iSP1507-AX : Electrode Dimensions

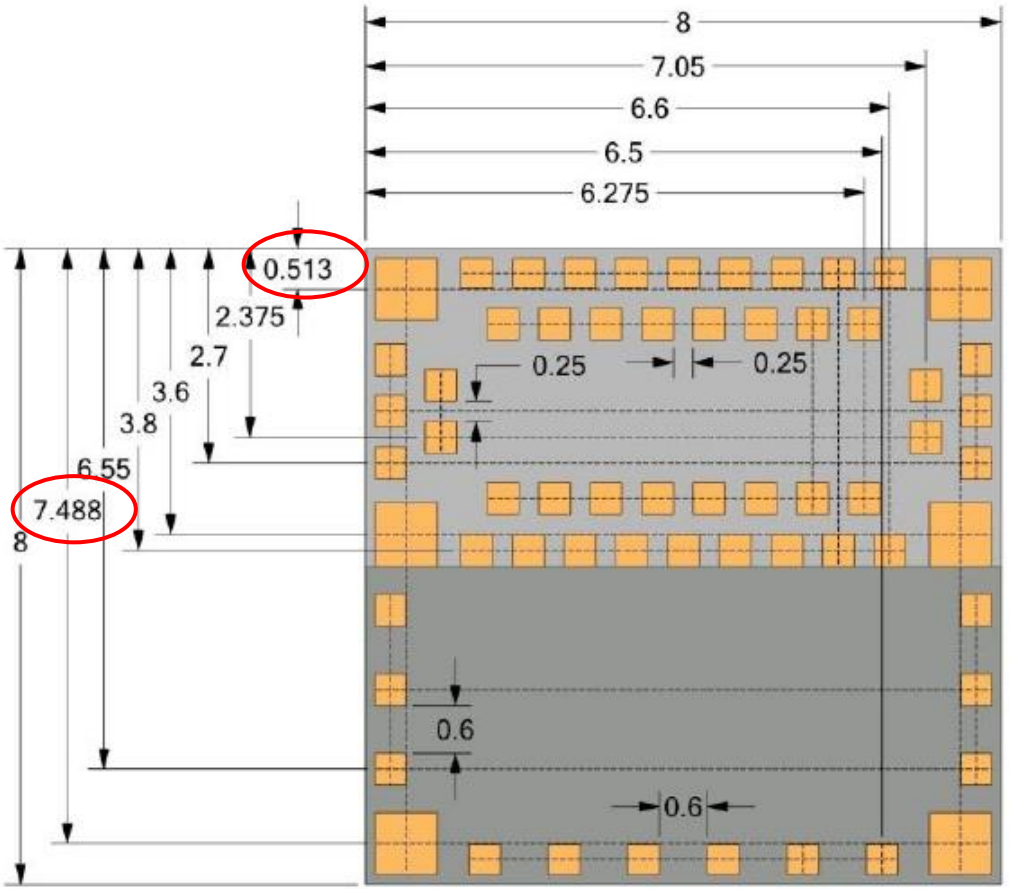
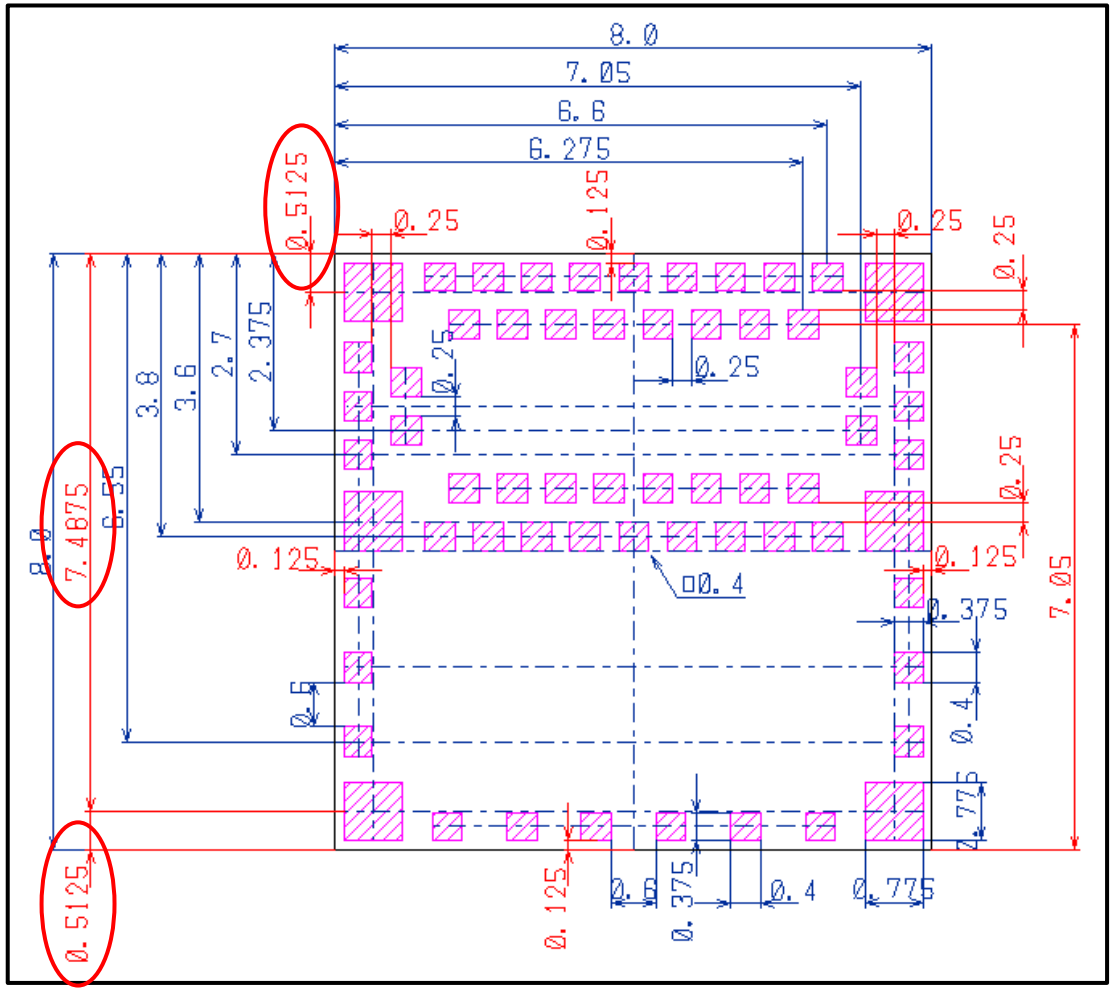
Q1.
Regarding the dimensions of the red circles, if the terminal positions are evenly spaced above and below, they do not match the dimensions on the drawing. Is it okay to assume that the dimensions on the drawing are rounded and that the terminal positions are evenly spaced above and below?

Q2.
I was unable to confirm this from the drawing, but are the values and positions of the remaining red line dimensions correct?
